**STAFF REPORT  
KETCHUM PLANNING AND ZONING COMMISSION  
MEETING OF FEBRUARY 9, 2021**

**PROJECT:** Westcliff Townhomes Pre-Application Design Review

**FILE NUMBER:** P21-007

**Exhibit B:**  
**Planning Review #1 Comments**  
**and**  
**Applicant Response**

A5

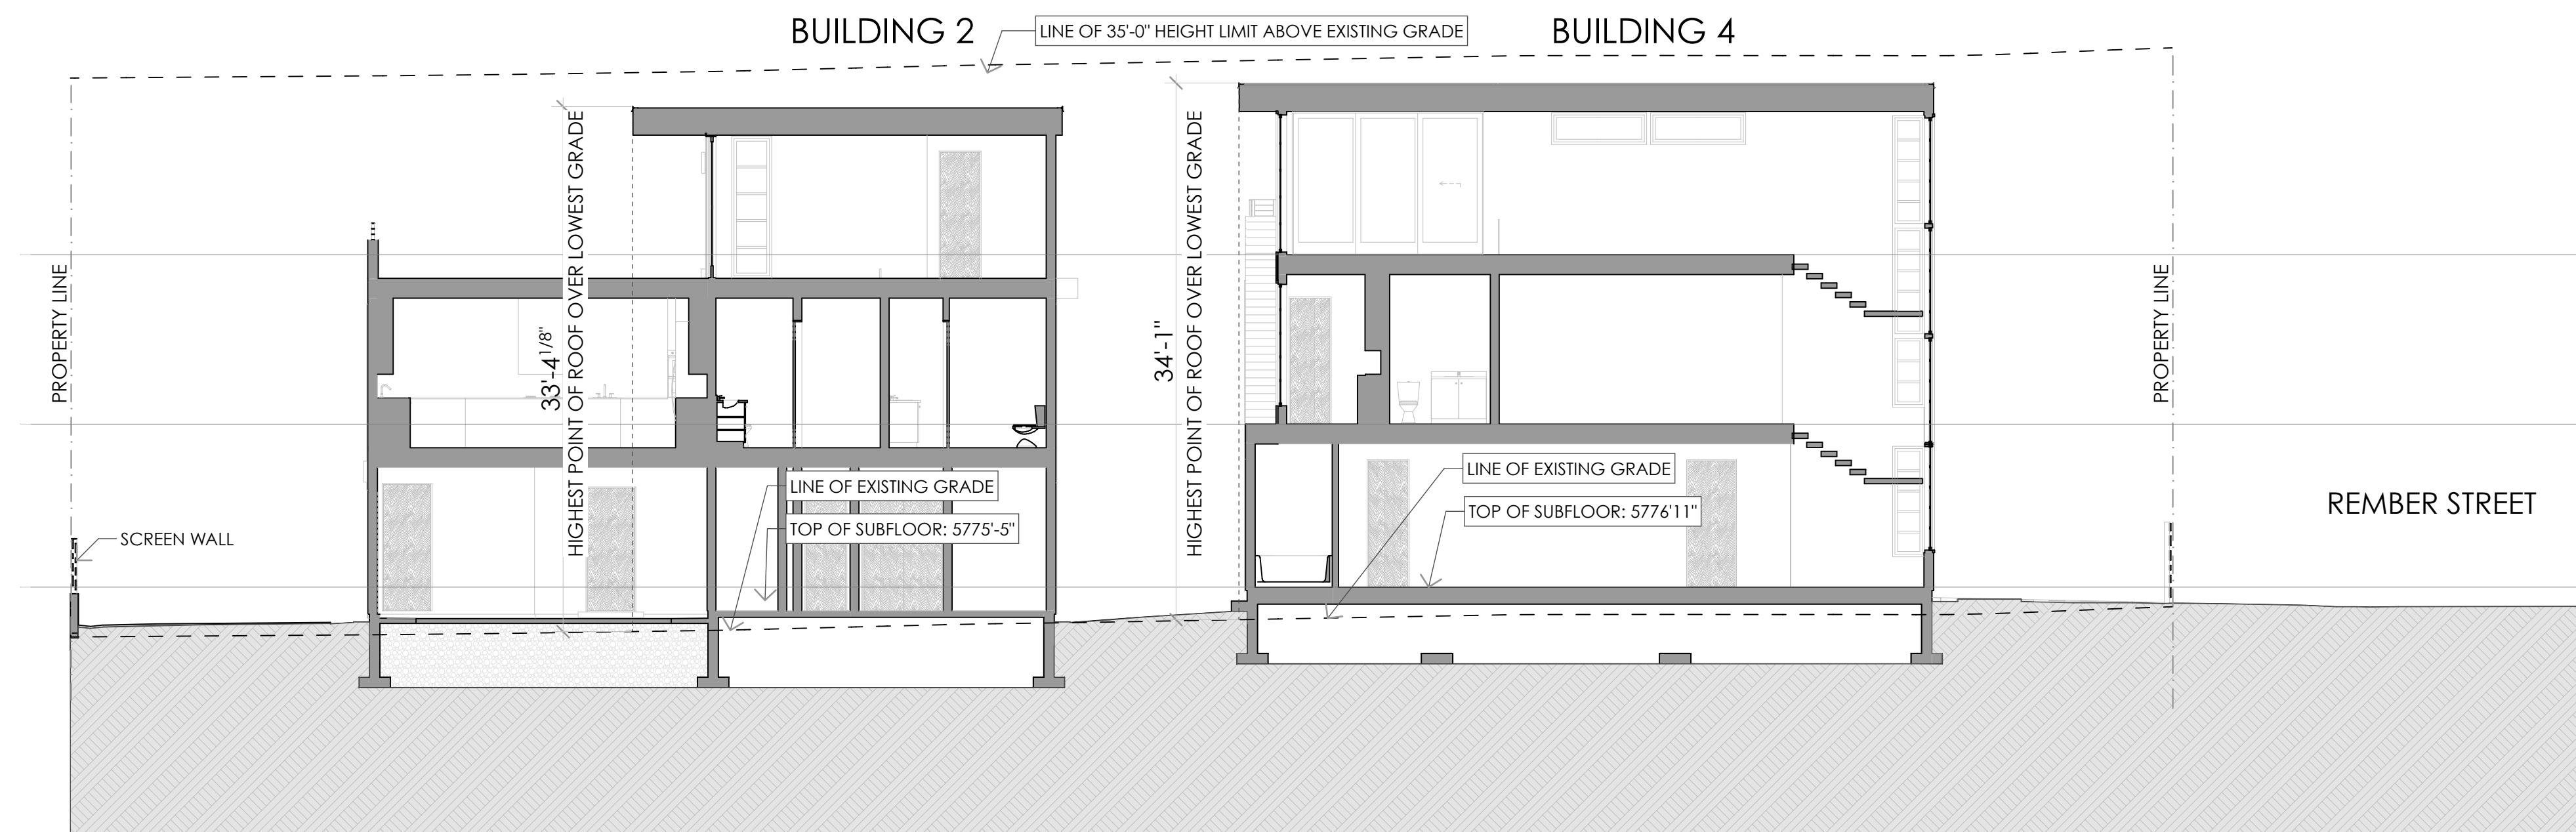
11	A5 Building Elevations	Sheet A5 indicates the elevations of the finished floors at the first level, second level, and third level. The elevations should also indicate the maximum height of each townhome unit.	<i>Overall building height from finish grade has been added to the building elevations on sheet A5, and the highest point of roof over lowest grade height is called out for each building on the building sections on page A7</i>
12	A8 Color Board	The color and material sample board must show all exterior material used on the façade of the structure (Ketchum Municipal Code §17.96.040.C.2i), including the balcony's steel railings and garage doors.	<i>The color board now lists the railings and garage doors as well as the other materials for the building.</i>

ISSUE:  
 1-18-2021  
 2004  
 A8

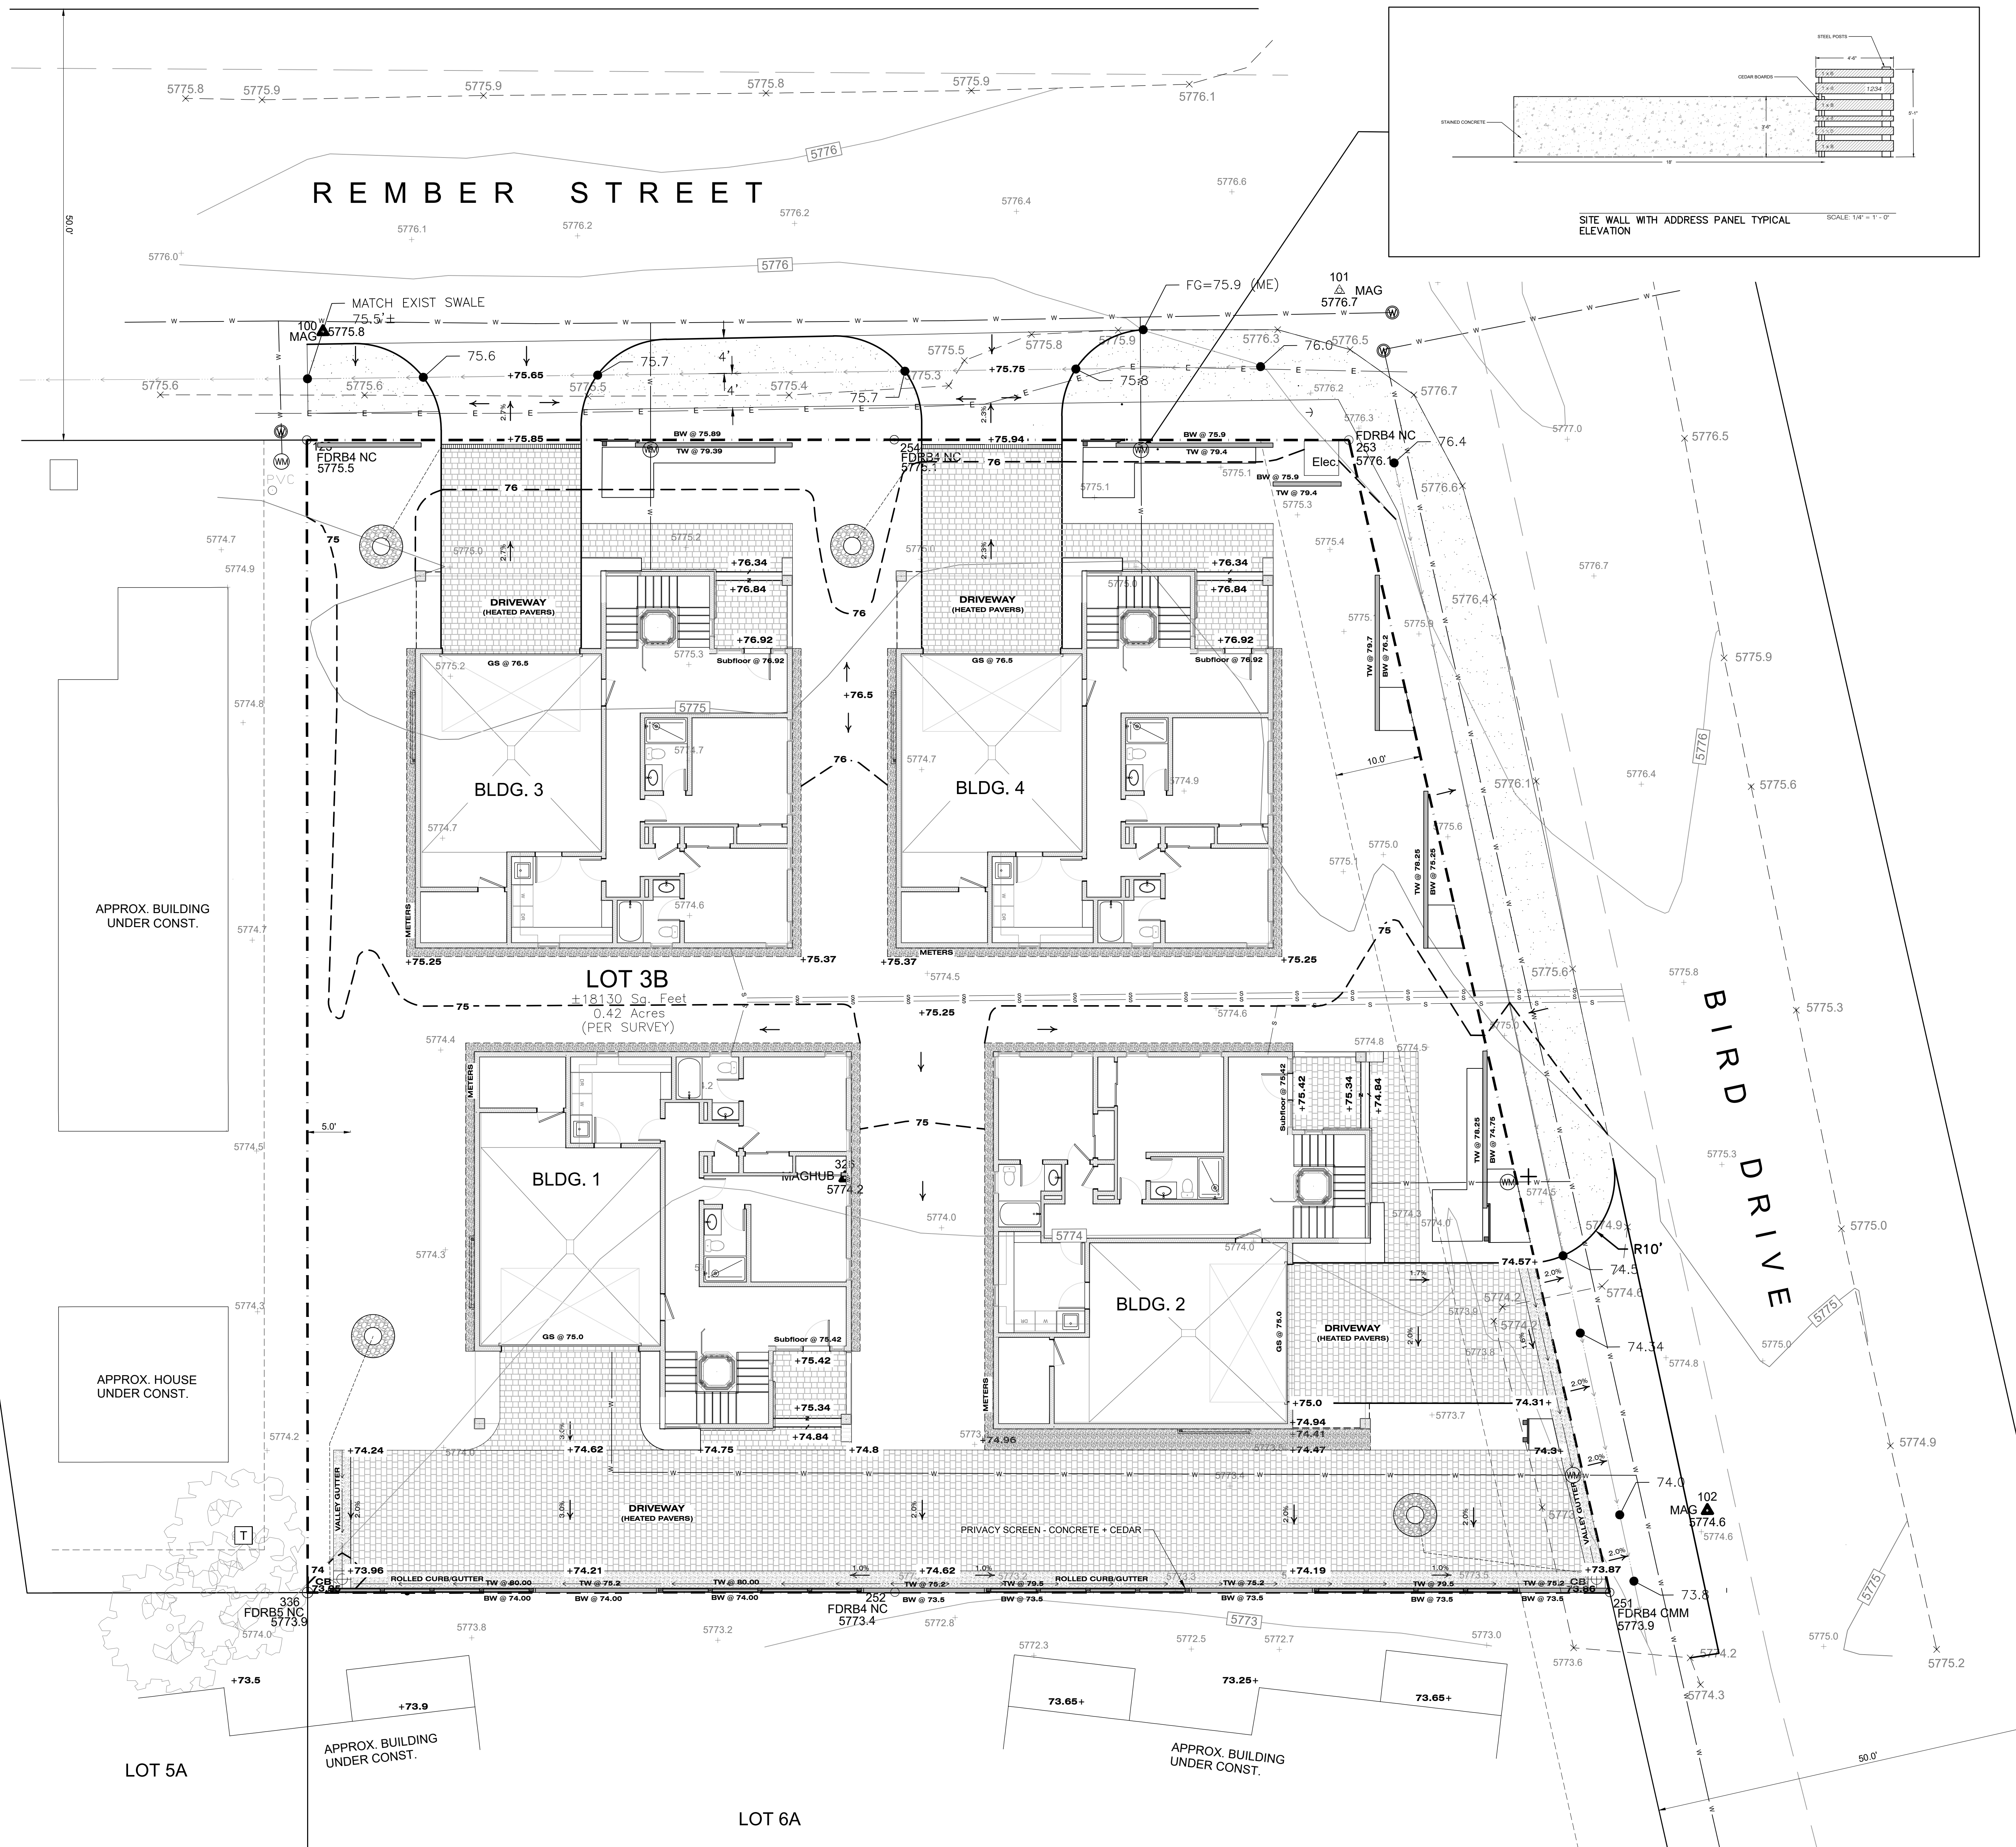
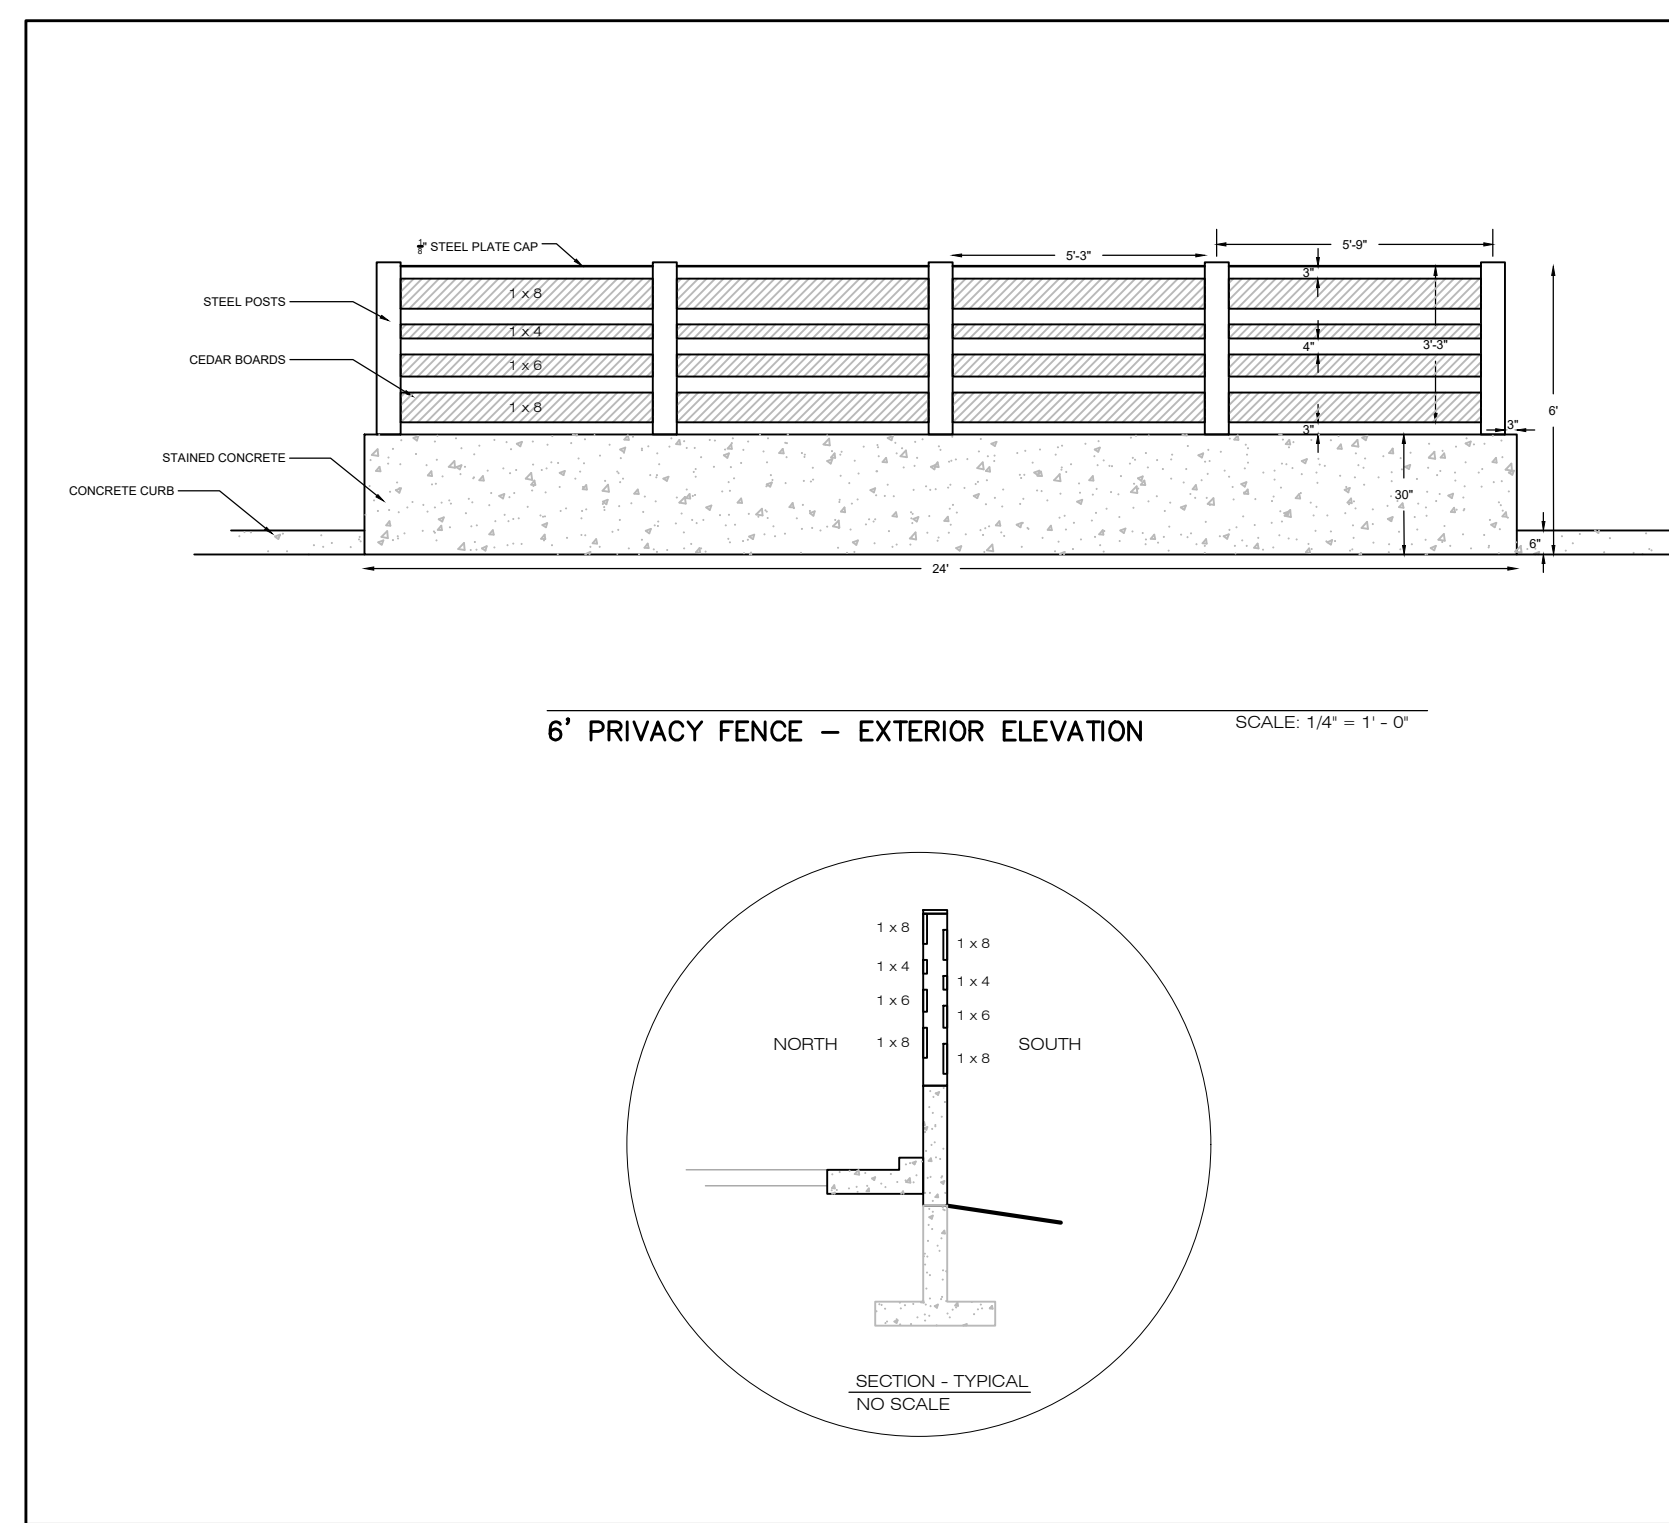
Item #	Sheet Title	Planning Review Comment Review #1 January 27, 2021	<i>Applicant Response and Description of Correction to Plans</i>
1	A1	<p>The permitted FAR in the General Residential High Density (GR-H) Zoning District is 0.5. The Planning &amp; Zoning Commission may allow an increased FAR subject to Design Review (Ketchum Municipal Code §17.124.040.B). Ketchum Municipal Code does not guarantee 1.4 as the allowed FAR. New developments may be permitted an increased FAR above 0.5 at the Commission’s discretion through Design Review. To receive more floor area, new buildings must complement the scale and character of the surrounding neighborhood.</p> <p>Your FAR calculations include a 2,800-square-foot parking credit for groundwater issues. The project site’s groundwater issues must be verified by an Idaho-licensed engineer (Ketchum Municipal Code §17.124.040.B.2b). If the city determines that the site conditions preclude underground parking, 350-square-feet per required parking space may be subtracted from the project’s total square footage.</p>	<p><i>Project proposed FAR is .67 including the 2800 S.F. parking credit for ground water issues.</i></p> <p><i>Butler Associates, our local Idaho-licensed Geotechnical Engineer has detailed the ground water issues in his report, which will be part of the application package. Butler recommends that there be no underground structures on the property due to high water table found in test pits dug in August of 2020.</i></p>

2	A1	<p>The project plans should note the total open space proposed for the multi-family residential development. The minimum required open space area in the GR-H Zone is 35% (Ketchum Municipal Code §17.12030).</p>	<p><i>The proposed open space for the project is 35.7%, lot area to total building footprint. This is now noted on the cover sheet A1 under Building Data.</i></p>
3	A1 & C (Survey)	<p>The legal description on Sheet A1 and the Survey indicate the development is located on Lots 3A and 4A of Bavarian Village Subdivision. The Ketchum City Council approved</p>	<p><i>The legal description noted on Sheet A1 has been corrected to reflect the lot line</i></p>
